SUBJECT: TAYLOR PARK CONSOLIDATION
SUBDIVISION REFERENCE #64/96

PURPOSE: To request Council authority for the dedication of a portion of the Marine Way-10th Avenue Connector and to advise Council of an adjustment to the related subdivision configuration.

SKETCH #2

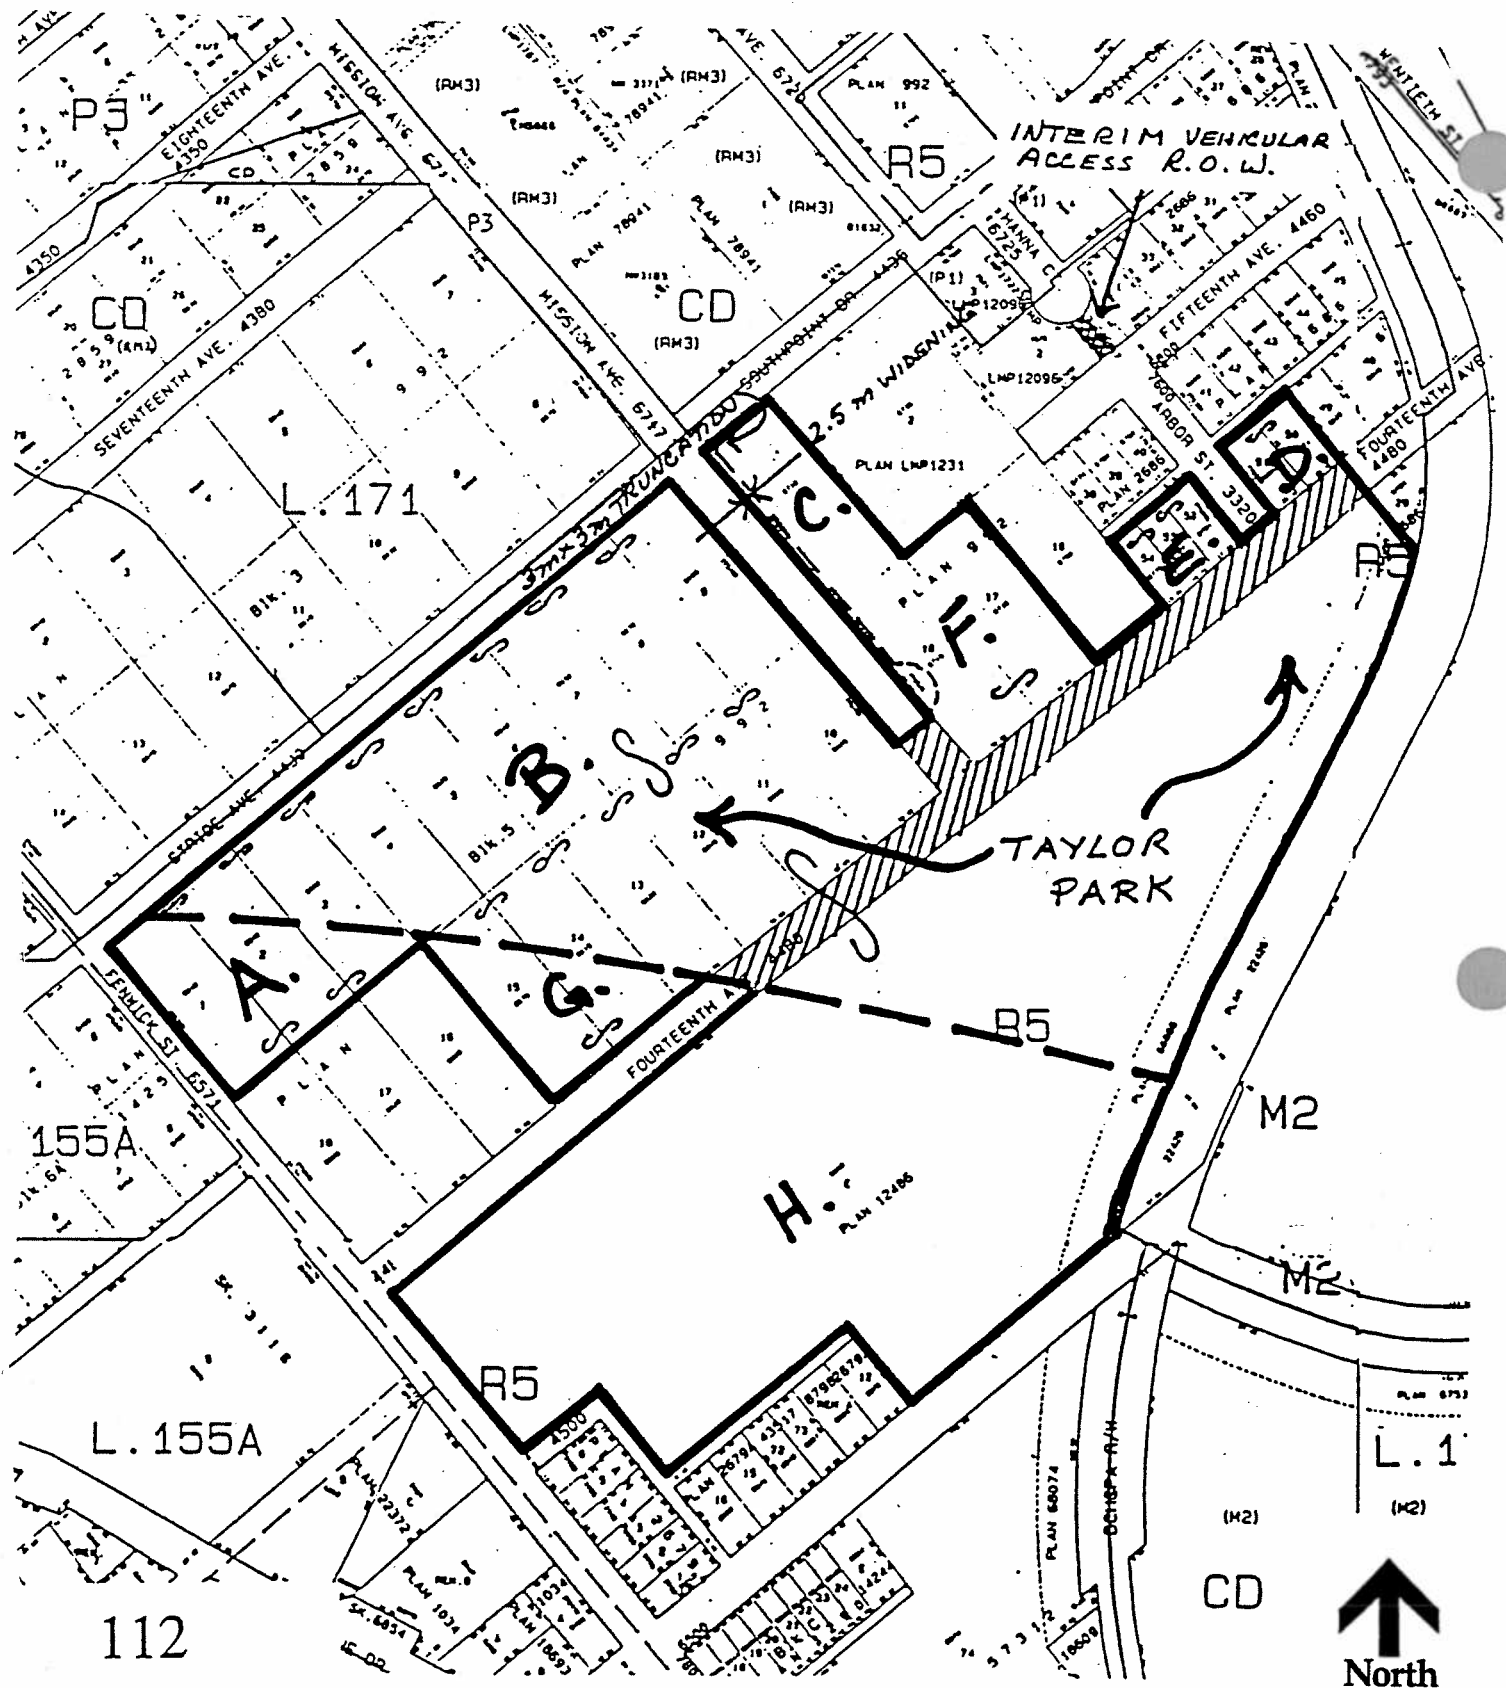
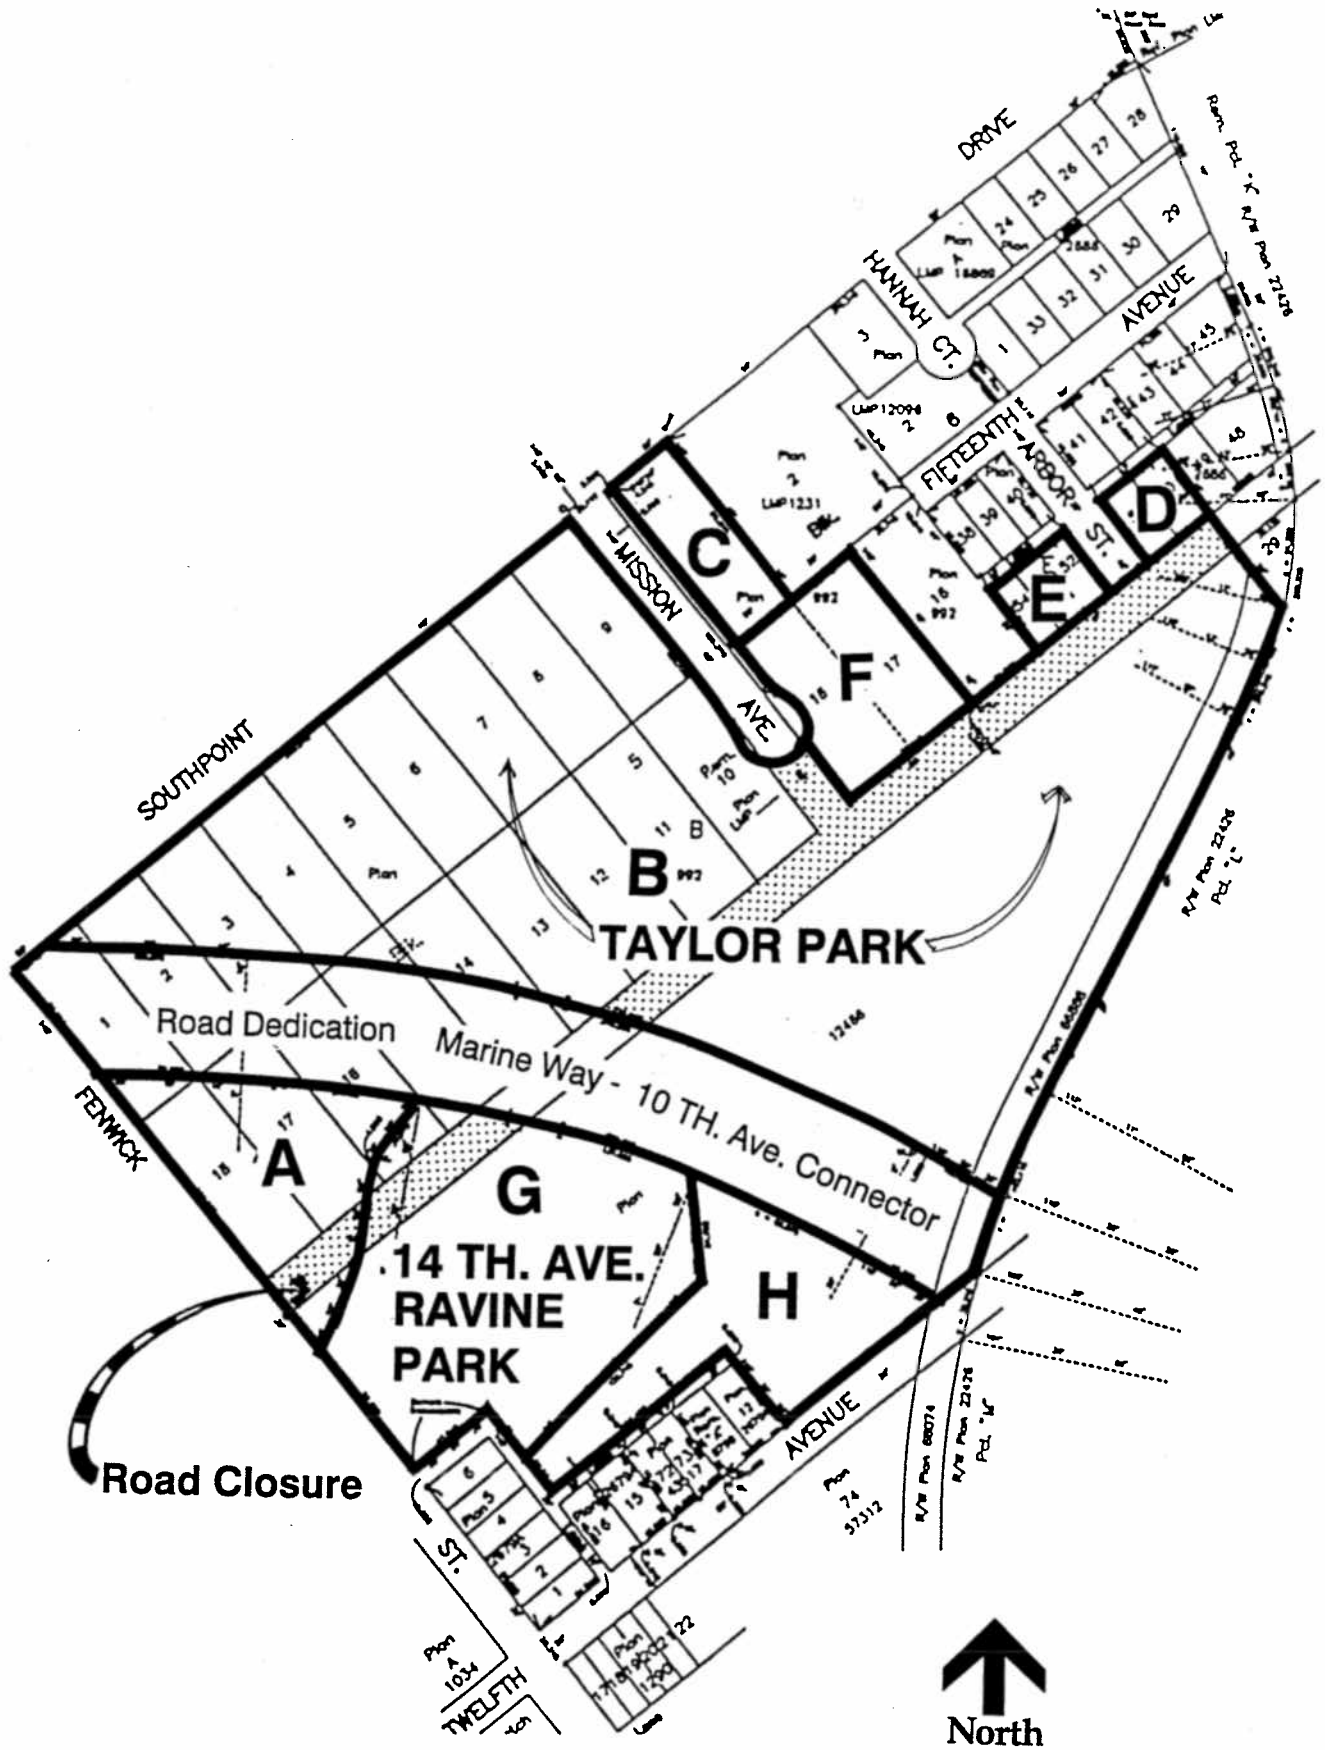
As both Taylor Park and the 14th Avenue Ravine Park have been dedicated as Park, and the right-of-way requirements for the Marine Way-10th Avenue Connector in this area have now been defined, it is desirable to adjust the configuration of the subdivision as illustrated in Sketch #2 *attached*. Council approval of the road dedication for the Connector is requested in this regard.

1. **THAT** Council authorize the dedication of the road right-of-way for the Marine Way-10th Avenue Connector as shown on Sketch #2.
